MAP(P) 22-07 Village of Turner Trace Townhomes

Planning & Building Department Staff Report

RE: MAP(P) 22-07 Village of Turner Trace Townhomes Review #1

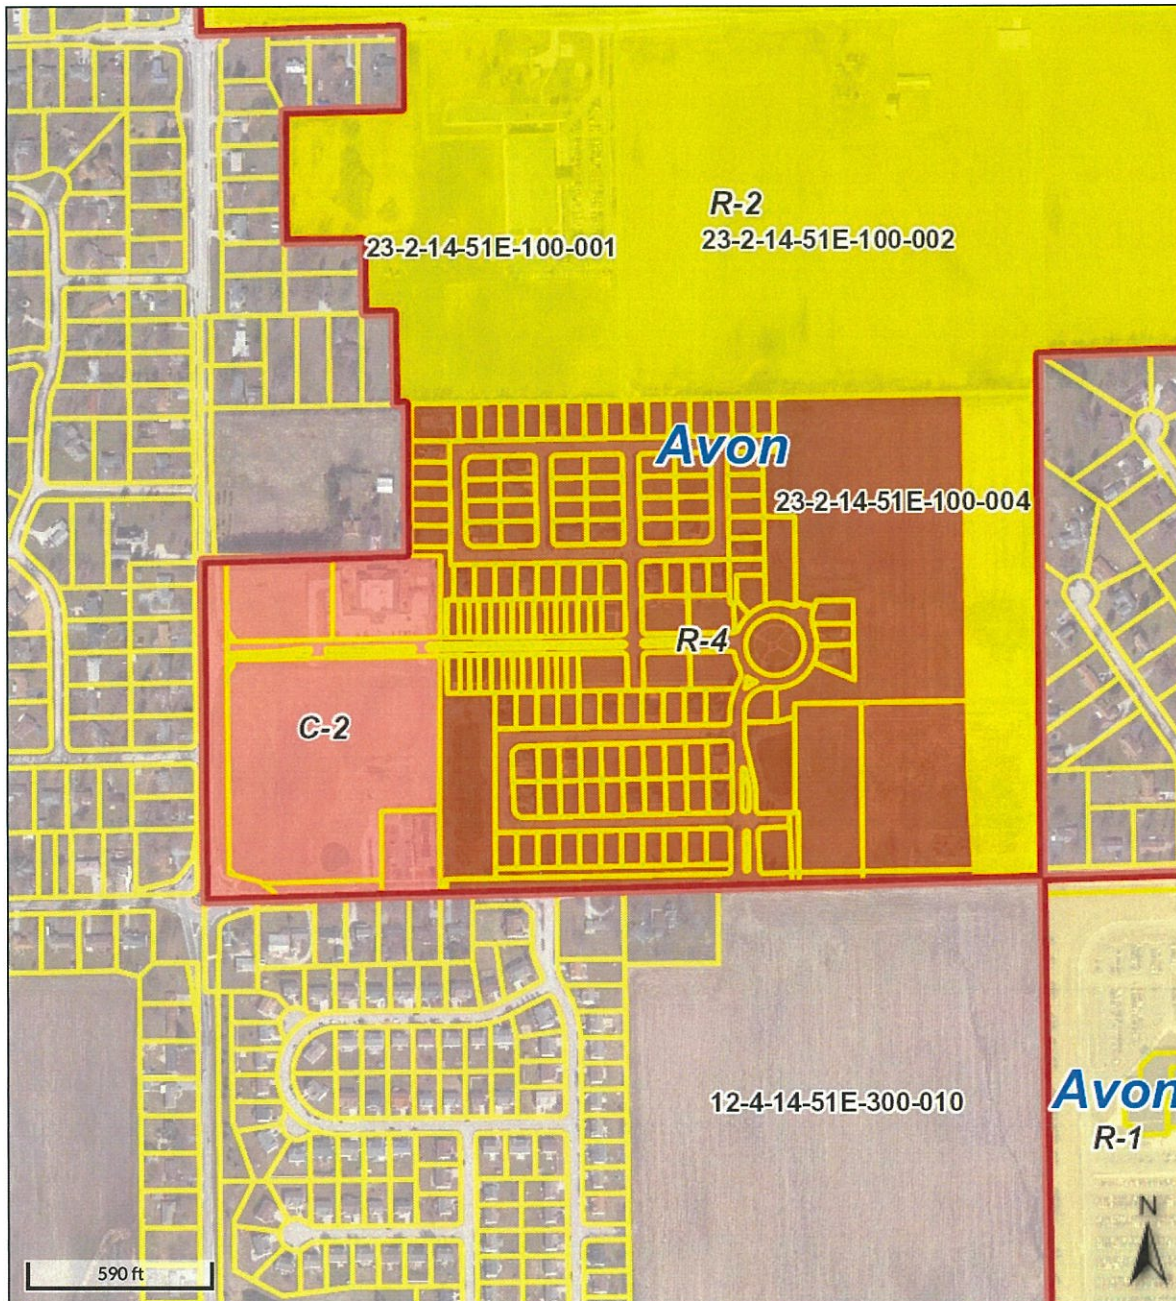
Lot Standards: The proposed uses and lot layout are consistent with the zoning ordinance as modified by VAR97-11, which modifies the front yard setback for the development.

Sidewalks: Internal sidewalks are shown at 5' width.

Open Space: The Subdivision Ordinance requires 10% open space. This section, as a continuation of the Villages of Turner Trace, has little open space, but the development as a whole complies with the requirements of the Ordinance. The proposal, therefore, is consistent with the requirements of the Subdivision Control Ordinance.
